CITY OF KELOWNA

MEMORANDUM

File No.: Z04-0003
(3360-20)

Purpose: To rezone from the A1-Agriculture 1 zone to the RU1h-Large Lot Housing (Hillside) zone in order to facilitate a 43 lot single detached housing subdivision

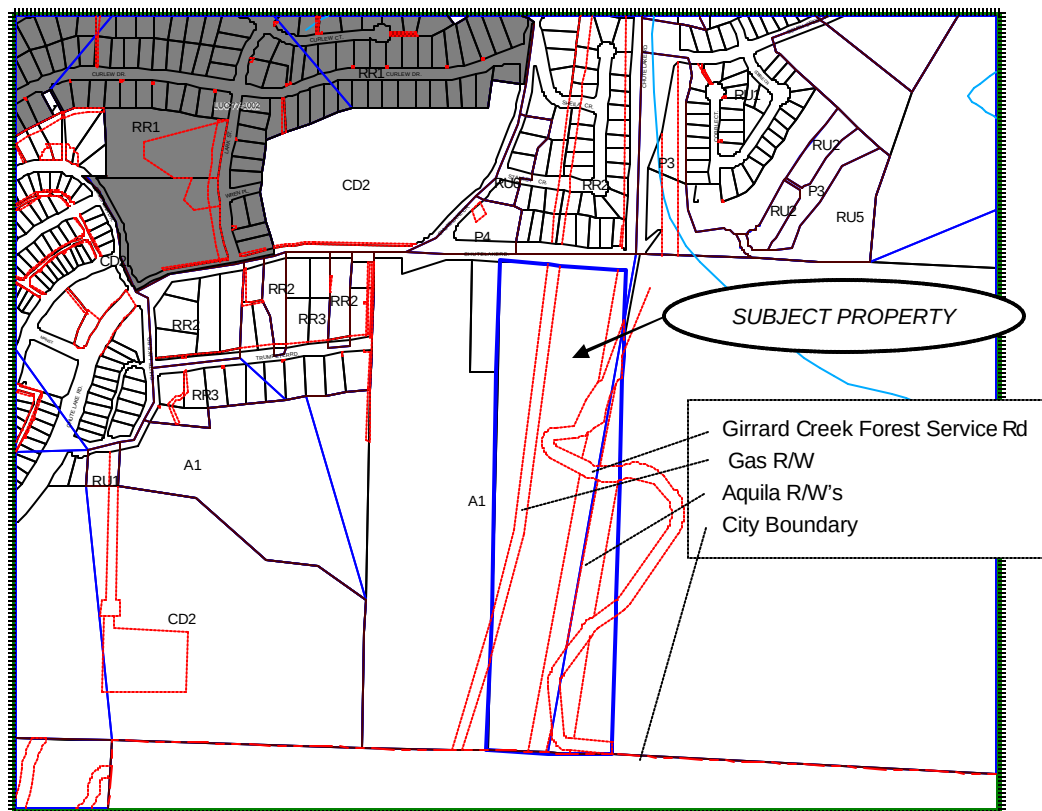
The property is located off the south side of Chute Lake Road, west of the Gillard Creek Forest Service Road. In addition to the forest service road running south through the property, there is a gas right of way and dual Aquila transmission line right-of-ways running north-south through the property as shown on the above map.

- b) The upper portion of the property above the 520m contour elevation does not have water service at this time. Therefore, this portion of the property should not be considered part of the zone amendment application unless water system upgrades are proposed and there is an amendment to the OCP.

- c) The maximum contour elevation for water service is 520m, based on the elevation of the Adams reservoir. The upper portion of this property above this contour elevation is not serviceable at this time unless further system facilities are built. Some lots in the lower portion may be affected by this elevation; therefore on the Lot Grading Plan identify the maximum service contour for water and specify the maximum floor elevation that can be built to satisfy Bylaw requirements.

- d) A Collector Road is required in approximately the same location as the existing Forestry Service Road on the East side of the property. This road is required as part of this subdivision as it fronts the development. The Transportation Section indicated that the road section may eliminate parking and allow for two 3.5m vehicle lanes and 1.5m bike lanes (for a road width of 10m) within an 18m dedication. Urbanization (curb & gutter, separate sidewalk and street lighting etc) is required fronting the development. Where other lands front the road it may remain as a rural cross-section. The alignment of this road needs to be finalized and approval obtained from the Ministry of Forests.

At this time it will be designated as an urban Minor Hillside Collector Road in accordance with City alternate standard Drawing TYP-04 with parking/access on both sides (15.50m dedication, 11.0m (boc) road). The cul-de-sac end should make provision for extension in the future i.e. the curb should be squared off fronting lot 33.

The existing hydro corridor is frequently used by the public for access between Chute Lake Road and the South Slopes and Gillard Area. It was also the main route of access during the fire for emergency crews. Parks wants to protect this public access route by establishing a public access ROW agreement over the parcel similar to the route of access (walkway) under the hydro corridor in Neighbour 2 around the Southridge subdivision. The proposed subdivision property lines would need to be adjusted from Lot 18 south to Lot 25 to prevent privatization of the corridor.

The basic lot layout concept as it impacts the Terasen Gas right-of-way is acceptable to Terasen Gas except for Lots 12 & 13 where the lot boundary should be re-adjusted so as not to be in the centre of the right-of-way where the pipeline is located. Detailed comments available through the subdivision application.
